Council Reference: DA10/0222.30 LN85548
Your Reference:

Council Submission to Department of Planning Modification Application to Casuarina Town Centre Concept Plan Approval MP06_0258 MOD 15 (Council reference DA10/0222.30) at Lot 51 DP 1264557; No. 10 Grand Parade CASUARINA

Assessment of Modifications Proposed as Part of this Application

Figure 1: Partial Ground Floor Plan

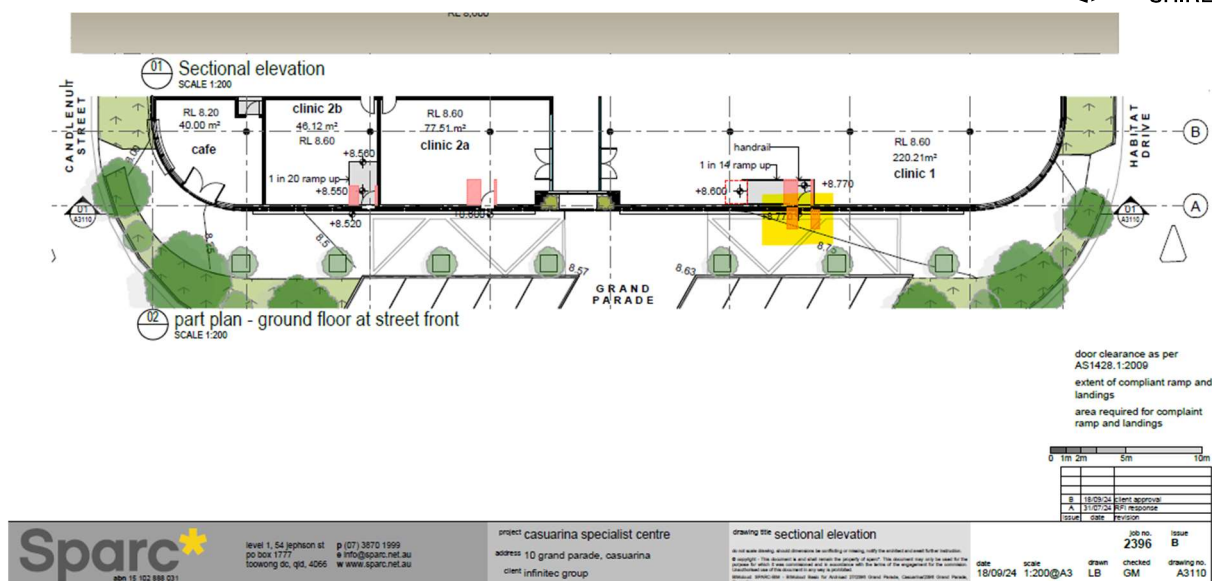
In reviewing this, the provision of additional pedestrian access to the development is considered to represent an improvement to the previous design. However, review of the updated submitted plans indicate that there may be some works required on Council's road reserve to facilitate this. The below figure 1 appears to demonstrate some works (highlighted) outside of the subject development site. It is not clear from the submitted legend what this works represent and as such it is not possible to provide a full assessment, however please note that Council would not support the provision of steps/ramps etc. within the road reserve and these should all be located on site.

It is requested that, in the event of approval, NSW Planning, Housing and Infrastructure ensure that compliant equitable pedestrian access is achievable and provided to each tenancy as required.
